Mechanical Addendum Two

March 10, 2015

PROJECT TITLE: COLUMBIA CAMPUS CONDENSATE PUMP REPLACEMENT - LIEBER COLLEGE  
STATE PROJECT NUMBER H27-2206

Columbia Campus Condensate Pump Replacement – Lieber College  
University of South Carolina  
State Project Number H27-Z206

**STANDARD ANCHOR ASSEMBLY**

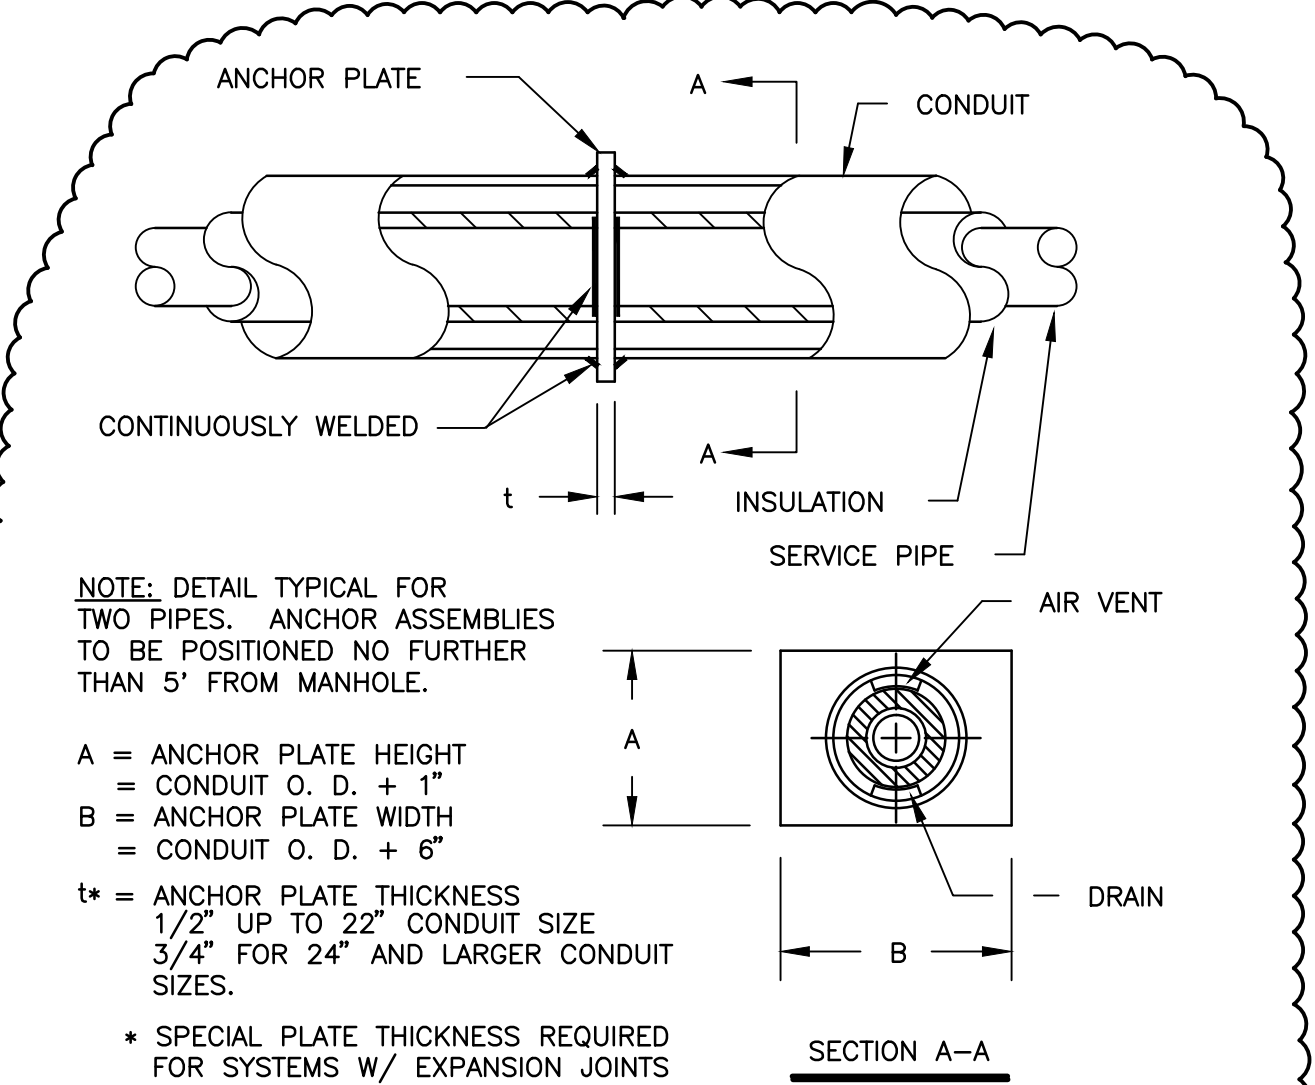
| 3.              | <u>Clarification:</u> Question: Drawing M1 & M2 has a note Anchor Block per detail. There is the no detail. Answer: Detail has been added to sheet M3. See revised sheet attached.   |

13. Revision: Reference Drawing M3. See the attached revised Drawing M3-REV1. A detail for the anchor block has been added.

NOTE: DETAIL TYPICAL FOR TWO PIPES. ANCHOR ASSEMBLIES TO BE POSITIONED NO FURTHER THAN 5' FROM MANHOLE.

A = ANCHOR PLATE HEIGHT  
= CONDUIT O. D. + 1"  
B = ANCHOR PLATE WIDTH  
= CONDUIT O. D. + 6"  
t\* = ANCHOR PLATE THICKNESS  
1/2" UP TO 22" CONDUIT SIZE  
3/4" FOR 24" AND LARGER CONDUIT SIZES.  
\* SPECIAL PLATE THICKNESS REQUIRED FOR SYSTEMS W/ EXPANSION JOINTS

NOTE: A CONCRETE BLOCK SHALL BE CAST OVER THE PLATE AND CONDUIT AND SHALL BE AT LEAST 30" IN LENGTH AND SHALL EXTEND A MINIMUM OF 9" BEYOND THE TOP AND BOTTOM OF ANCHOR PLATE.

**MAIN BUILDING STEAM AND HOT WATER PIPING SCHEMATIC**

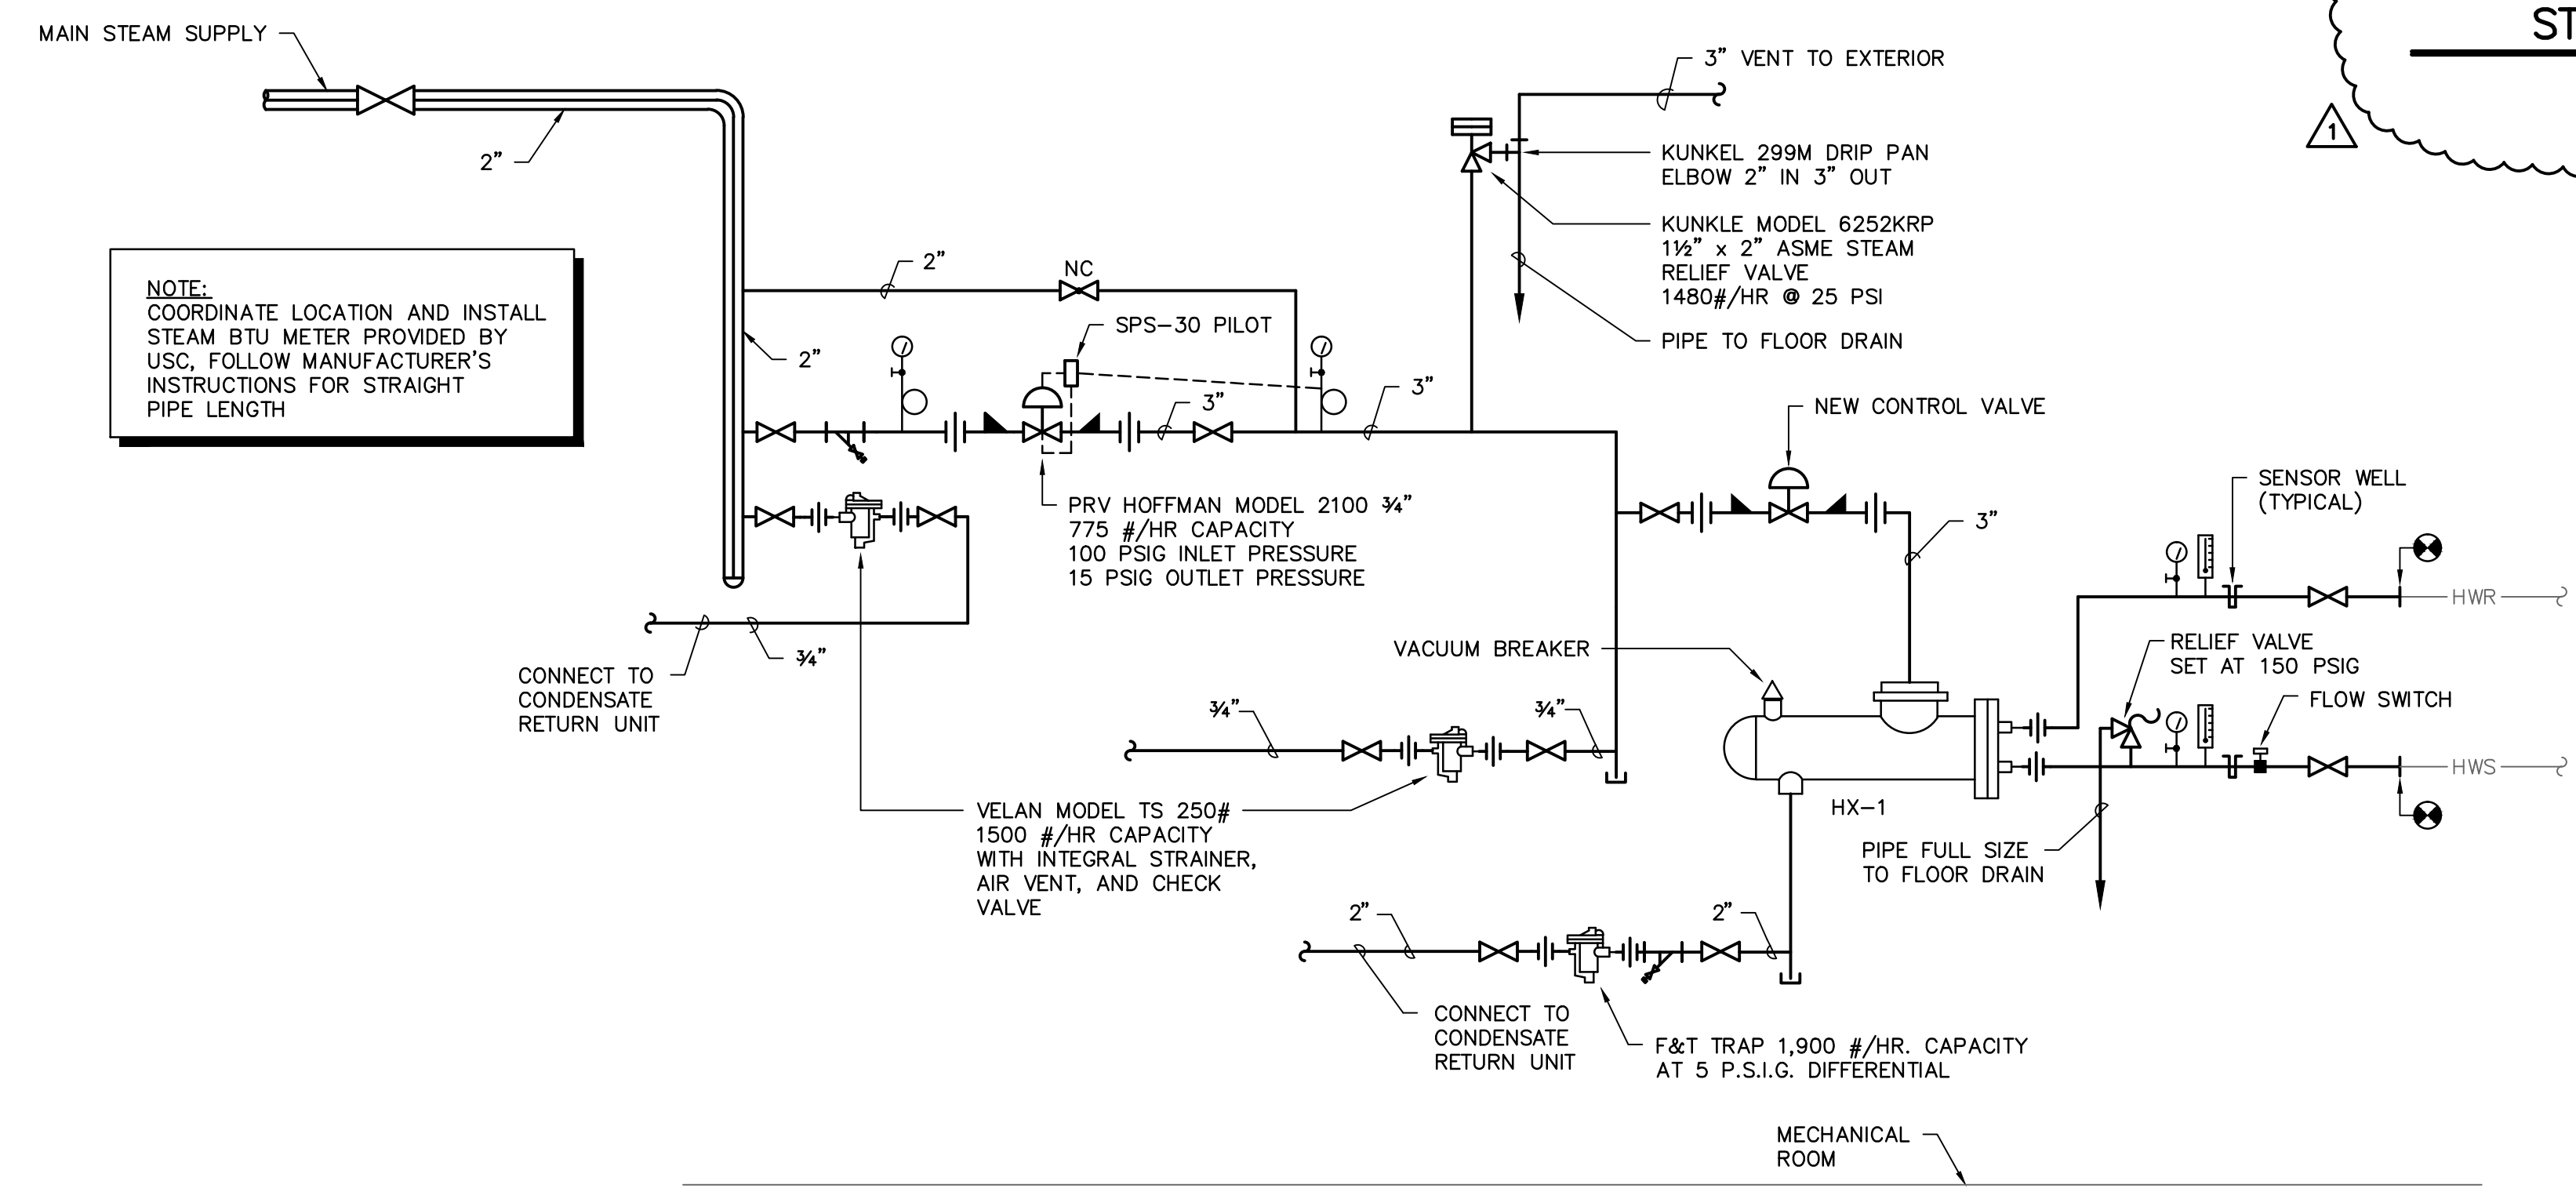
| 4.              | <u>Clarification:</u> Question: What are the specifications for the flow switch on M3 – Steam and hot water schematic? Answer: Water flow switches shall be equal to the Johnson Controls P74.   |
| 5.              | <u>Clarification:</u> Question: What are the specifications for the control valve on M3 – Steam and hot water schematic? Answer: All automatic control valves shall be ball valves fully proportioning and provide near linear heat transfer control. The valves shall be quiet in operation and fail-safe closed. All valves shall operate in sequence with another valve when required by the sequence of operations. All control valves shall be sized by the control manufacturer, and shall be guaranteed to meet the heating and cooling loads, as specified. All control valves shall be suitable for the system flow conditions and close against the differential pressures involved. Body pressure rating and connection type (sweat, screwed, or flanged) shall conform to the pipe schedule elsewhere in this Specification. |
